Appl. No.: 10/560,391  
Amdt. Dated March 19, 2010  
Reply to Office Action Mail-Dated April 6, 2009

**Amendments to the Drawings:**

### REMARKS/ARGUMENTS

FIG. 1

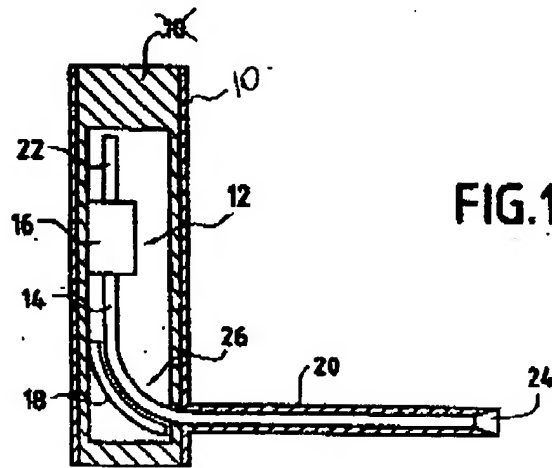
4. Applicant has amended Figures 1 and 14 to properly depict the main hole 10 and the lateral hole 20. In Figure 1, the reference character 10 was moved to properly point to the main hole 10. In Figure 14, lines depicting the main and lateral holes were added with lead lines of reference characters 10 and 20, respectively, extending therefrom. Support for these amendments are found at paragraph [0072] and [0092] of the specification.

- Figure 1 reference number 10 is moved so it now points to the borehole;
- Figure 4 – relabeled as separate figures at Figures 4A1 and 4A2;
- Figure 5 – relabeled as separate figures as Figures 5A and 5B;
- Figure 6 relabeled as separate figures as Figures 6A and 6B;
- Figure 7 – relabeled as separate figures as Figures 7A and 7B;
- Figure 8 – relabeled as separate figures as Figures 8A and 8B;
- Figure 9 relabeled as separate figures as Figures 9A and 9B;
- Figure 10 – relabeled as separate figures as Figures 10A and 10B;
- Figure 12 – added reference numbers 31 for successive cells, 73, 75 for axial links and 80, 82 for rings;
- Figures 13A,B,C – added reference numbers 73, 75 for axial links; and
- Figure 14 – added lines to depict the main hole 10 and the lateral hole 12, and adjusted lead lines for 10, 12 to extend therefrom.

FIG. 4A1

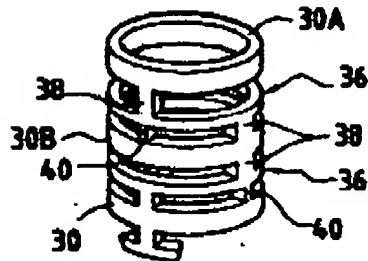
6. a. Applicant has canceled Claim 31 thereby rendering moot this objection.
6. b. Applicant has amended Figure 4A such that each figure is labeled 4A1 and 4A2. Applicant has also amended paragraph [0061] of the specification to indicate that 4A1

shows an implementation in an unloaded position, and 4A2 shows an implementation in a loaded position. A corresponding amendment has been made to paragraph [0078] to indicate the new figure numbers.

FIG. 5A

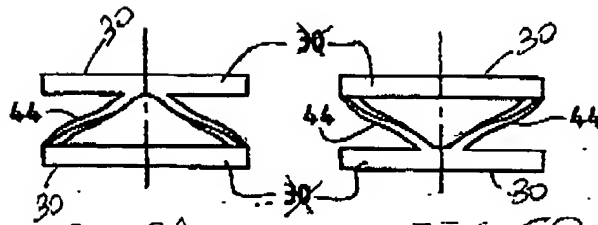
6. c. Applicant has amended Figure 5 to identify each figure as 5A and 5B, and Figure 6 to identify each figure as 6A and 6B as requested. Corresponding changes have been made to paragraphs [0062,63] of the specification.

6. d. As indicated in 6c above, Applicant has amended paragraph [0063]. This paragraph now indicates that FIG. 5B is the same implementation of FIG. 5A rotated 90 degrees. Similar amendments have been made for FIGS. 6-10.

6. e. The Examiner suggests that reference character '30' in Figure 5 cannot be used as a reference character for in separate figures. Applicant has amended Figures 5A-9B such that the reference characters are used separately for each figure.

FIG. 7A

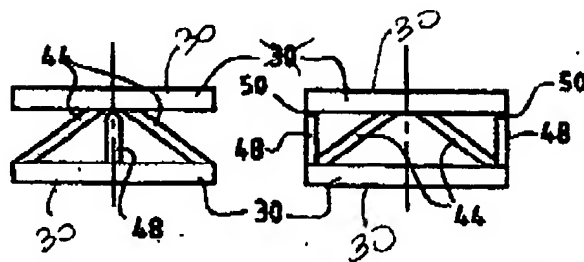
6. f. The Examiner has indicated that axial links and load supports are connected at both ends to adjacent rings 30 which would prevent flexion between adjacent rings 30 in Figs. 6-10. Applicant respectfully disagrees. First, the axial links 48 of Figure 7 are detached from ring 30 at one end 50 (see paragraph [0084]) and the axial links 56, 56' of Figure 9 are detached from the ring 30 at one end (see paragraph [0087]). Second, as described, for example, at paragraph [0085] "the basic cell structure (two suggestive rings 30) has different bending stiffness at 90°. There is a rigid direction (due to the axial link 46, 48) and a soft direction at 90° thereto." Third, as further described, for example, at paragraph [0086], the supports 52 can be pushed towards the centre of the shaft, but other movements are possible." Thus, flexion is permitted as described with respect to Figures 6-10 (at least).

FIG. 8A

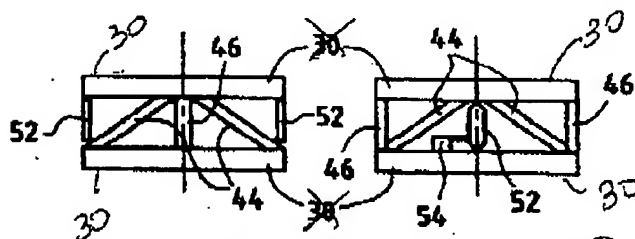
i. The Examiner suggests that FIG. 8 depicts the figure on the left with compression load supports connected to the upper ring, and the figure on the right illustrates the compression load support not connected to either the upper or the lower rings.

Applicant submits that Figures 8A and 8B, consistent with paragraph [0086] of the specification properly, depict compression load supports 52 positioned between the rings 30 and held in position by the spring mountings 54. Applicant further notes that paragraph [0065] has been amended to indicate that FIG. 8B is rotated 90 degrees from FIG. 8A.

FIG. 9A

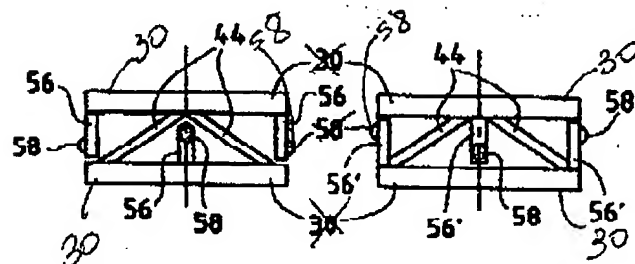
ii. The Examiner suggests that FIG. 9 depicts the figure on the left with load supports connected to the bottom ring, and the figure on the right illustrates the load supports connected to the upper ring. Applicant submits that Figures 9A and 9B,

consistent with paragraph [0087] of the specification, properly depict load supports 56 attached at one end to the upper ring, and load supports 56' attached at one end to the lower ring. Applicant further notes that paragraph [0066] has been amended to indicate that FIG. 9B is rotated 90 degrees from FIG. 9A.
